Proposal #09: 3180-03-74

Illinois – Lake Geneva
Bridge Ovr Nippersink Creek B64-007
STH 120
Walworth County

This is Addendum No. 01, which provides for the following:

Addendum No. 01
ID 3180-03-74
Revised Sheet 143
August 27, 2026

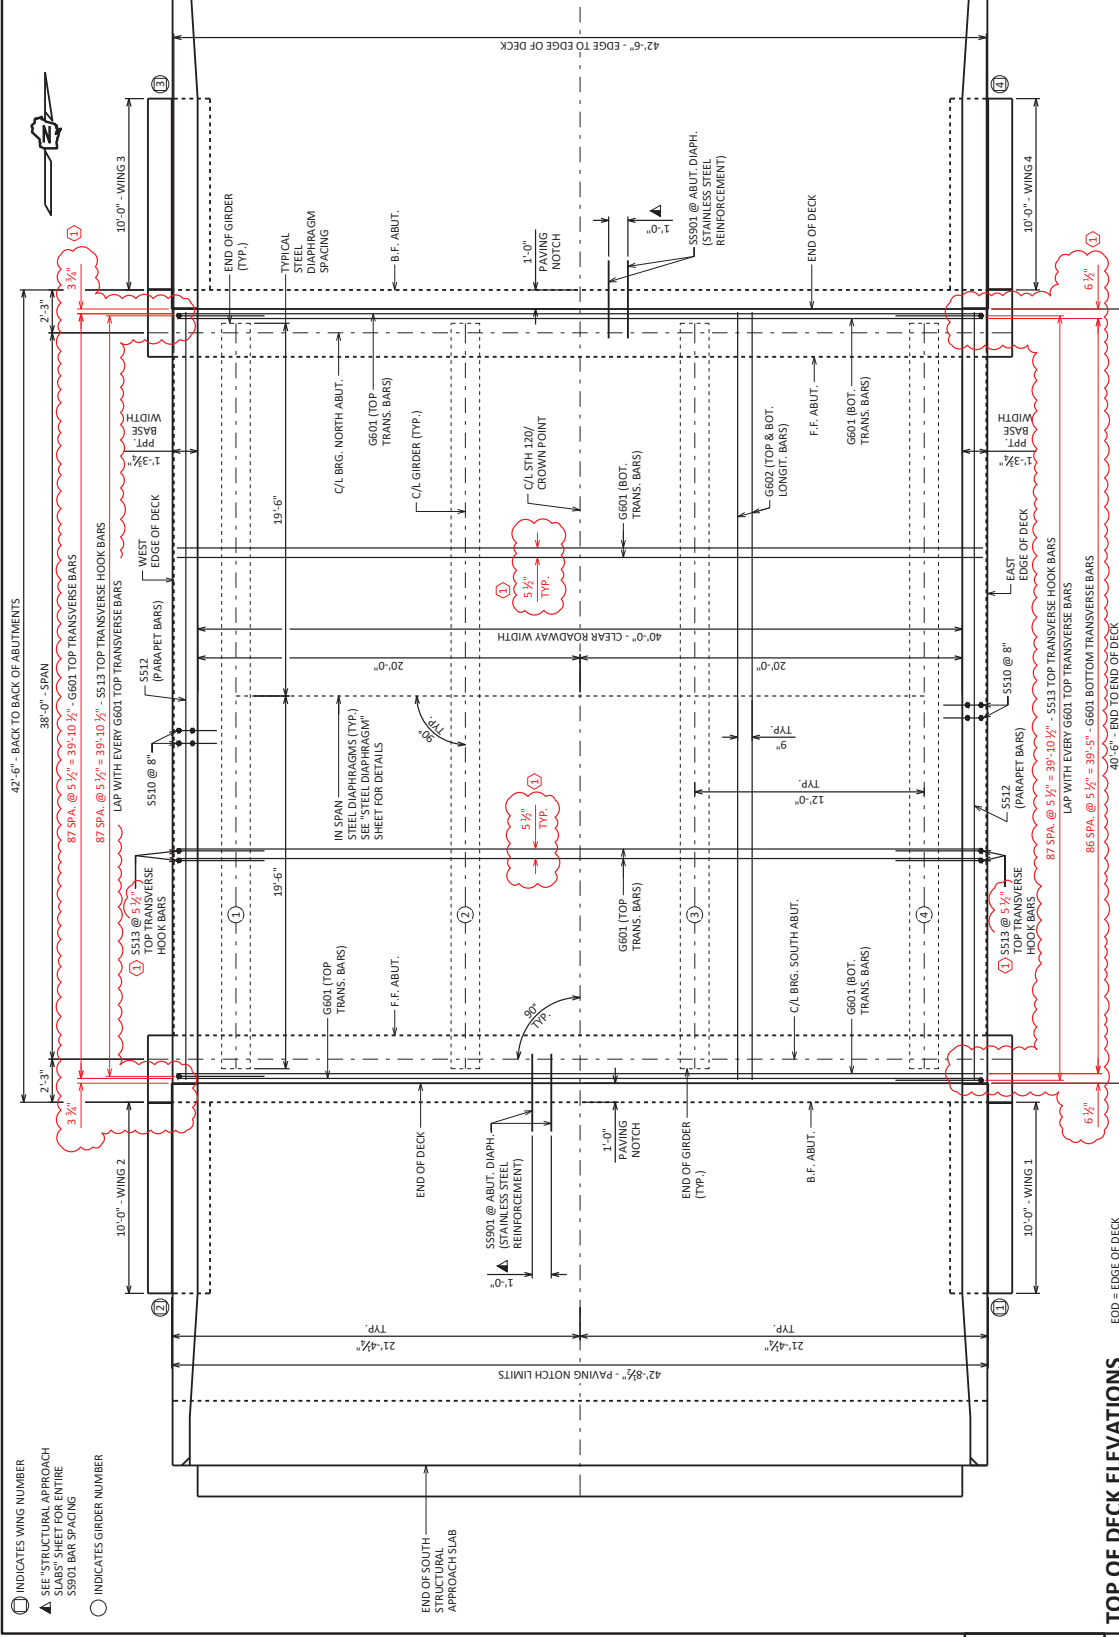
Revised Plan Sheets	
Plan Sheet	Plan Sheet Title (brief description of changes to sheet)
135	Structure Plans B-64-211: Quantities table updated.
143	Structure Plans B-64-211: Reinforcement spacing changed.
144	Structure Plans B-64-211: Reinforcement spacing changed.
145	Structure Plans B-64-211: Reinforcement spacing changed.
146	Structure Plans B-64-211: Bill of bars updated.

NO.	8/7/26	TRANSVERSE BAR SPACING	CAD
REVISION	DATE	BY	
STATE OF WISCONSIN DEPARTMENT OF TRANSPORTATION STRUCTURES DESIGN SECTION			
STRUCTURE B-64-211		DESIGNED BY JPH	EMF
SUPERSTRUCTURE PLAN		SHEET 10	143
